**STAFF REVIEW AND RECOMMENDATIONS
PUBLIC HEARING
SEPTEMBER 7, 2016**

ABBREVIATED PLAT: **VAIL ESTATES ADD #1 RSB BLOCK 1, LOTS 12 & 13**
LEGAL DESCRIPTION: **SEC 15, T18N, R01E, SEWARD MERIDIAN, AK**
PETITIONERS: **ELISHA CUSTOM HOMES LLC;
PBJJ INVESTMENTS LLC**
SURVEYOR: **COTTINI LAND SURVEYING**
ACRES: 1.893 ± PARCELS: 2
REVIEWED BY: **AMY OTTO-BUCHANAN** CASE: 2016-104

PRELIMINARY PLAT: **SOUTHLAND ADDITION NO. 1**
LEGAL DESCRIPTION: **SEC 05, T16N, R02W, S.M., AK**
PETITIONER: **BUDDY TWO INVESTMENTS, LLC**
SURVEYOR/ENGINEER: **PILCH SURVEYING / PIONEER ENGINEERING**
ACRES: **5.64** PARCELS: **4**
REVIEWED BY: **CHERYL SCOTT** CASE: 2016-108

A PLAT OF
VAIL ESTATES ADD. #1
 LOTS 12A & 13A, BLOCK 1

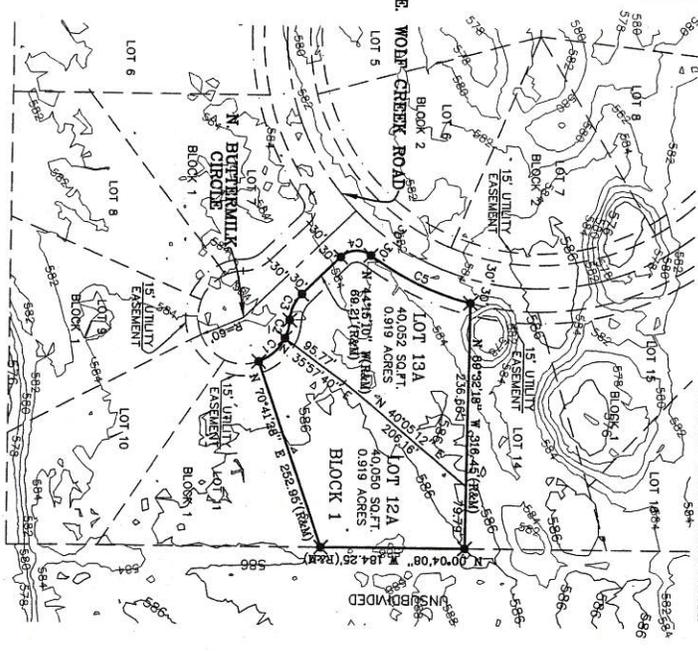
APPROVED AS SHOWN **CORRECTED**
 SIGN: **Josh Swanson** DATE: **8/19/16**
ENGINEERING & DESIGN

EXHIBIT G

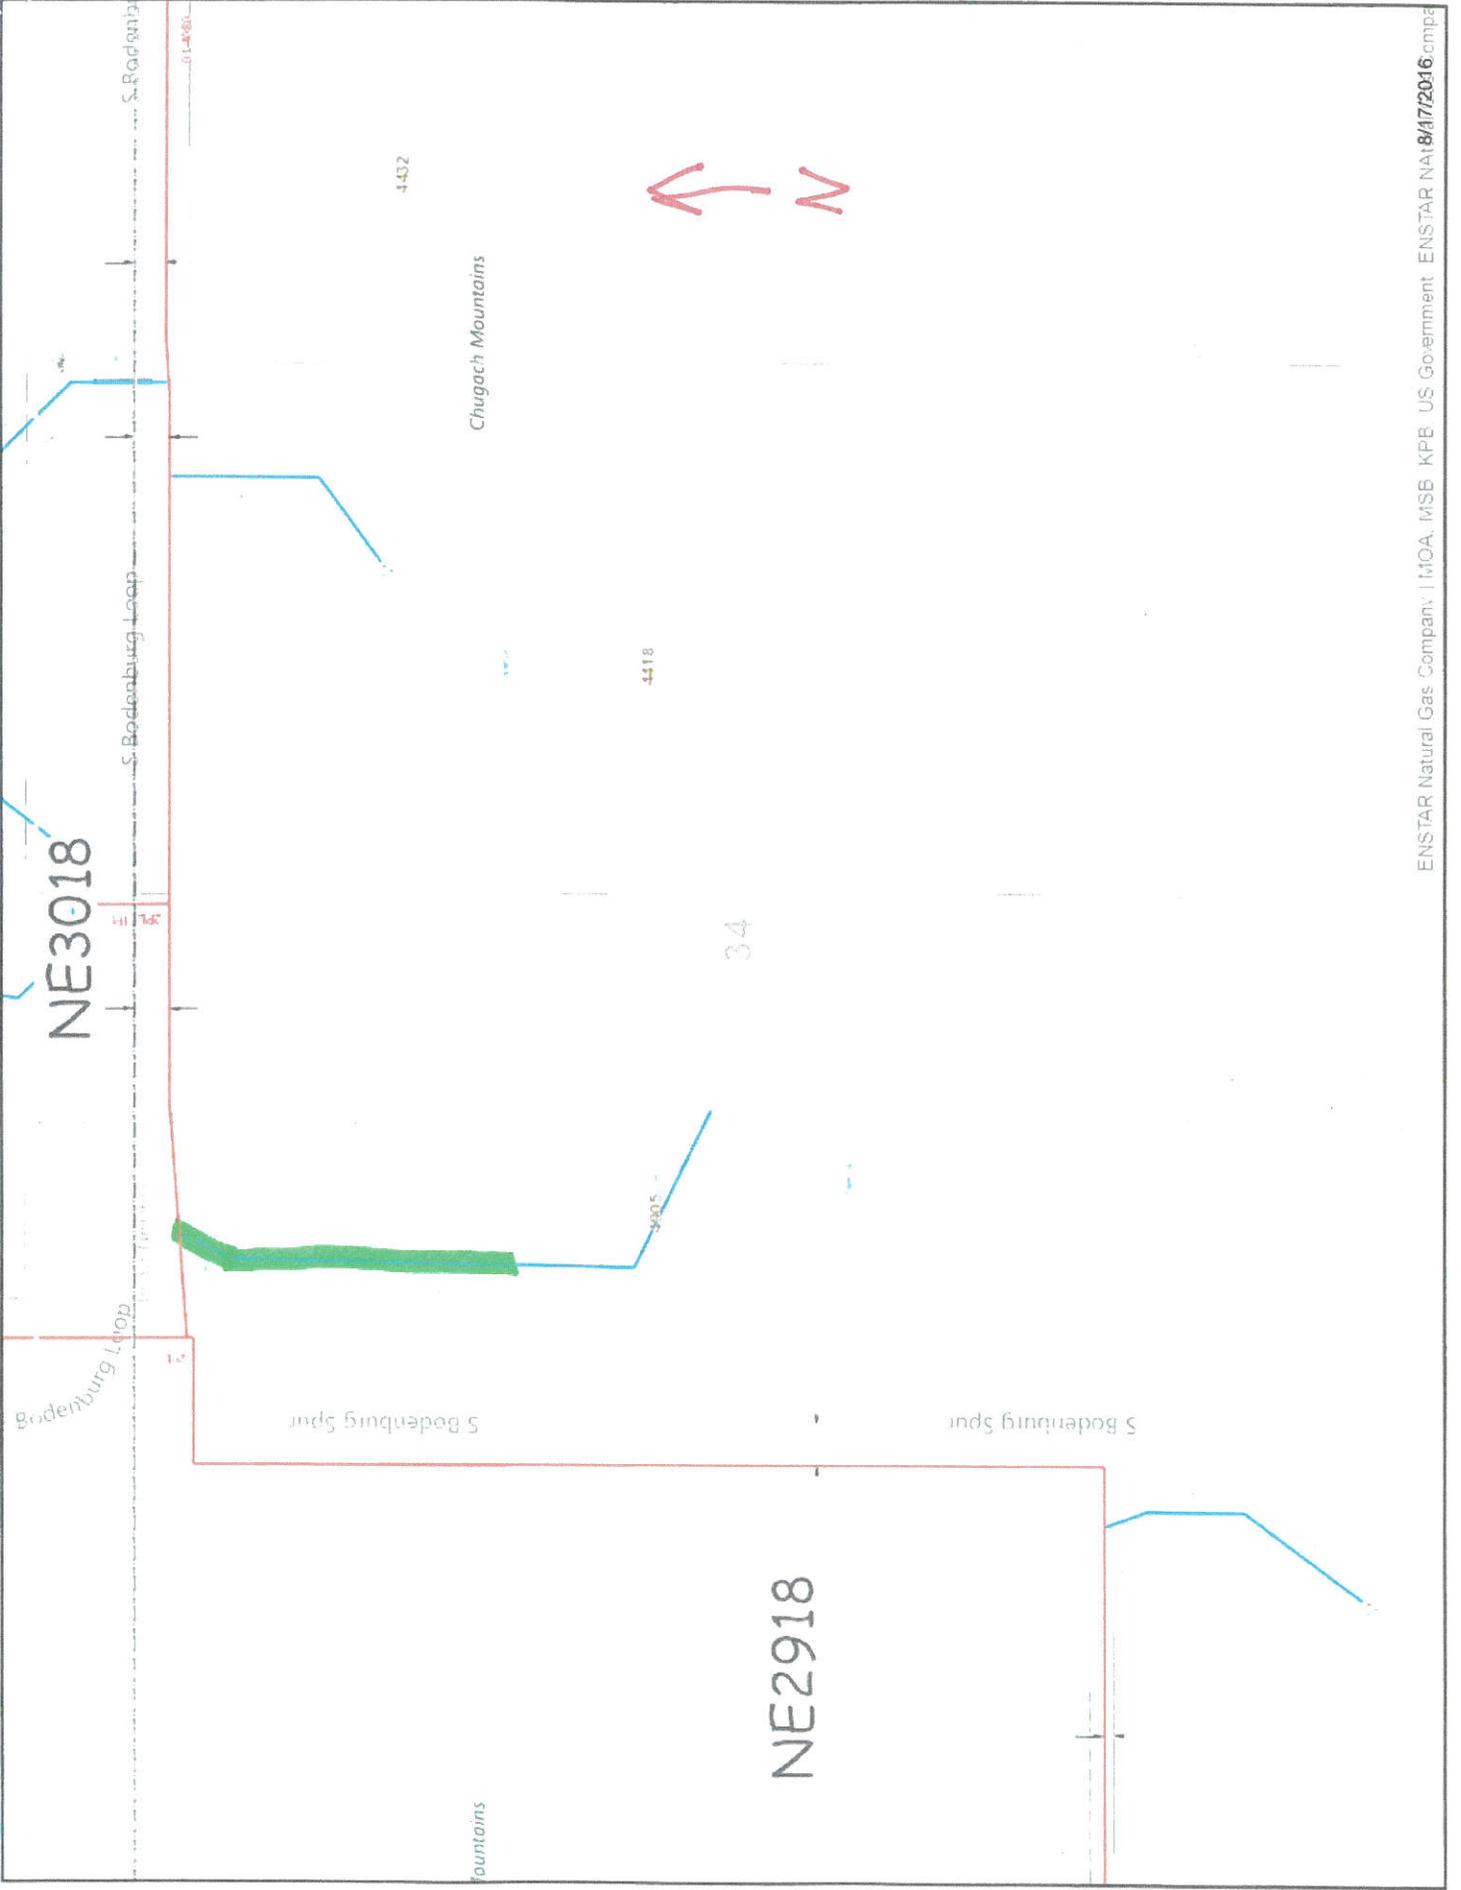
Utilities: (**Exhibit G**) Enstar requests a 10' natural gas line easement centered on the service line where it crosses proposed Lot 1 for service to proposed Lot 2. *Staff notes petitioner to grant the requested easement by document, record document and show on final plat (see Recommendation #5).* GCI approved as shown. MEA and MTA did not respond.

ENSTAR Natural Gas Company has reviewed the subject Abbreviated Plat and advises that there is an existing natural gas service line which crosses proposed Lot 1, in order to provide service to proposed Lot 2.
